FINAL DEVELOPMENT PLAN APPLICATION

Project/Property Address or Location: 1509 Blatt Blvd, Gahanna OH 43230		Project Name/Business Name (if applicable): Commercial Self Storage- Ohio	
Parcel ID No.(s):	Current Zoning: I-1	Total Acreage: 10	
Project Description: Business to Business storage of products and warehousing of goods. Non- residential. Self storage warehouses from 300 sq. ft to 5,000 sq ft for commercial use.			
APPLICANT Name (primary contact) -do <u>not</u> use a business name: Jim Sapp		Applicant Address: 8070 Castleton Road, Indianapolis, IN 46250	
Applicant E-mail: Jsapp@esapp.com		Applicant Phone No.: 317-863-2033	
BUSINESS Name (if applicable): Commercial Self Storage			
ATTORNEY/AGENT Name: same as above		Attorney/Agent Address:	
Attorney/Agent E-Mail:		Attorney/Agent Phone No.:	
ADDITIONAL CONTACTS (please list all applicable contacts)			
Name(s):		Contact Information (phone no./email):	
Contractor Circel City Contractors		Brent Kuhn, 317-710-7827,brent@circlecitcitycontractors.co

APPLICATION STAFF COMMENTS

Final Development Plan Response Letter

DEMOLITION PLAN
COMMERCIAL SELF STORAGE
1509 BLATT BLVD - GAHANNA, OHIO

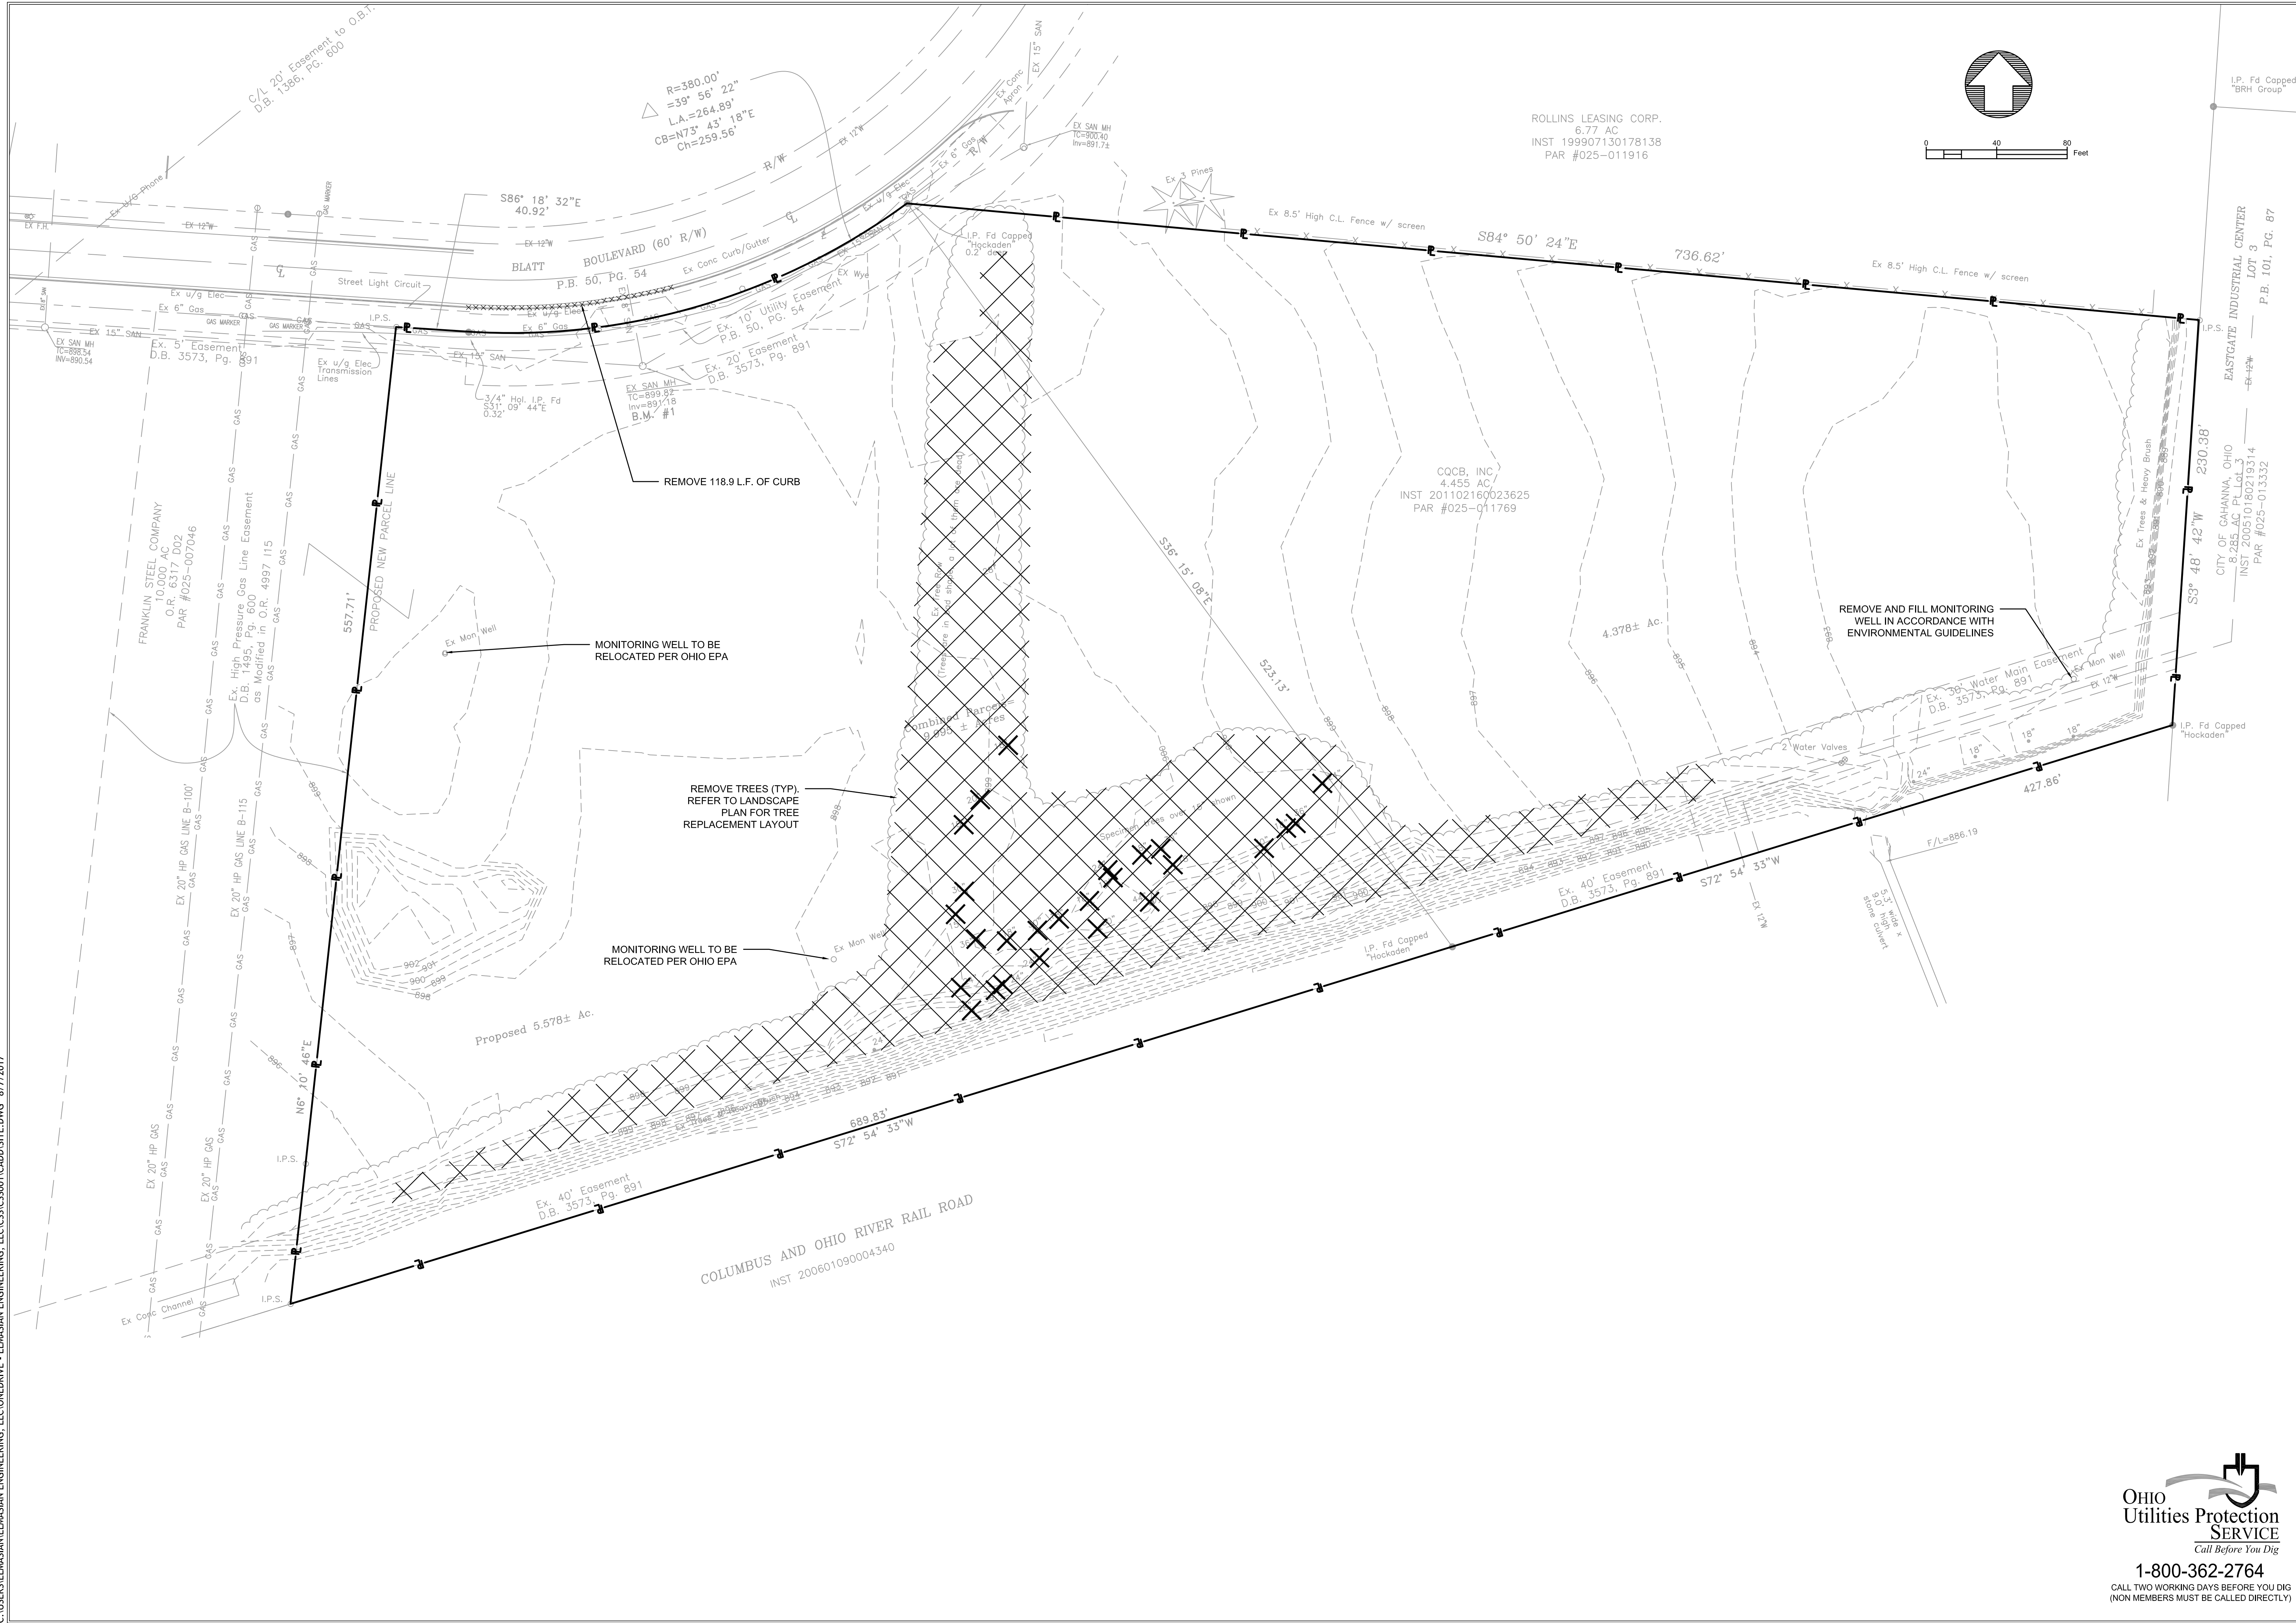
- The site access will be to Blatt Boulevard via a new curb cut.

We are aware of this and it is noted on the Demolition Plan sheet.

TYPICAL PAVEMENT SECTIONS
NO SCALE

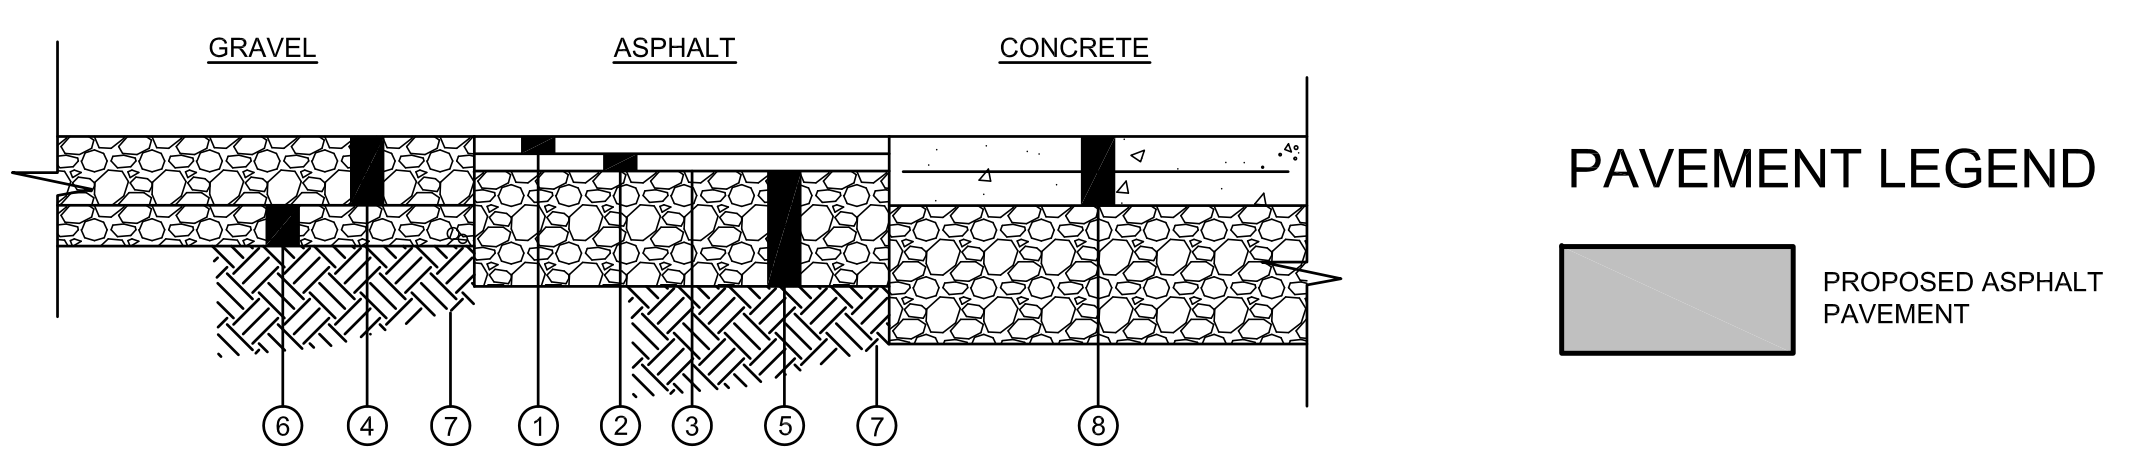
3. The portion of the roadway considered fire department access roadway shall be constructed as heavy duty in accordance with D102.1 of the Ohio Fire Code (see below).

- The portion of the roadway considered fire department access roadway shall be constructed as heavy duty in accordance with D102.1 of the Ohio Fire Code.

We will revise the plans to include this information.
